Streetworks

UTLD Traditionaire

PA Series Upgrade - January 2021

UTLD Decorative Post Top Nomenclature Transition Cross-Reference

UTLD Traditionaire Decorative Post Top Luminaire

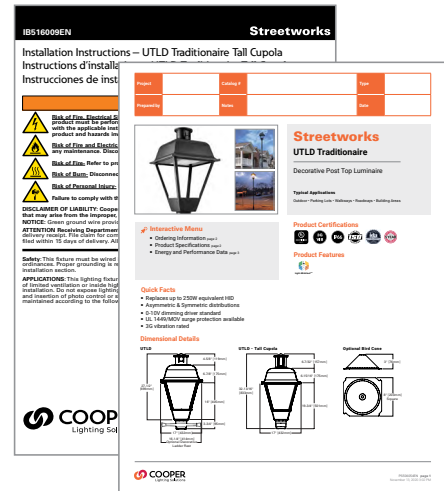
The Traditionaire LED outdoor luminaire displays the old-fashioned charm of traditional area lighting, enhancing any setting with distinctive styling. The high-lumen downlight configuration uses discrete LEDs with patented AccuLED Optics technology to deliver uniform and efficient illumination to pedestrian and roadway applications.

EXISTING	
Sample Numbers:	UTLD-AF24-30-D-U-T3-4N7-7030
Prefix	Description
UTLD	Traditionaire LED Downlight
Light Engine	Description
AF24	(1) Existing Light Panel Generation "AF"
Color Temperature	Description
_____	_____
_____	_____
_____	_____
_____	_____
_____	_____
_____	_____
_____	_____
Voltage	Description
U	Universal (120-277V)
347	347V
_____	_____
_____	_____
Distribution	Description
_____	No changes
Lens	Description
_____	No changes
Finish	Description
_____	No changes

NEW	
Sample Numbers:	UTLD-PA1-30-730-U-T3-BK-10K-PR7
Prefix	Description
UTLD	Traditionaire LED Downlight
Light Engine	Description
PA1	(1) New Light Panel
Color Temperature	Description
722	70 CRI / 2200K CCT
727	70 CRI / 2700K CCT
730	70 CRI / 3000K CCT
740	70 CRI / 4000K CCT
750	70 CRI / 5000K CCT
827	80 CRI / 2700K CCT
AMB	Amber 590nm
Voltage	Description
U	Universal (120-277V)
2	208V
8	480V
9	347V
Distribution	Description
_____	No changes
Lens	Description
_____	No changes
Finish	Description
_____	No changes

NEW	
CRI/CCT	Description
Moved Color Temperature to above
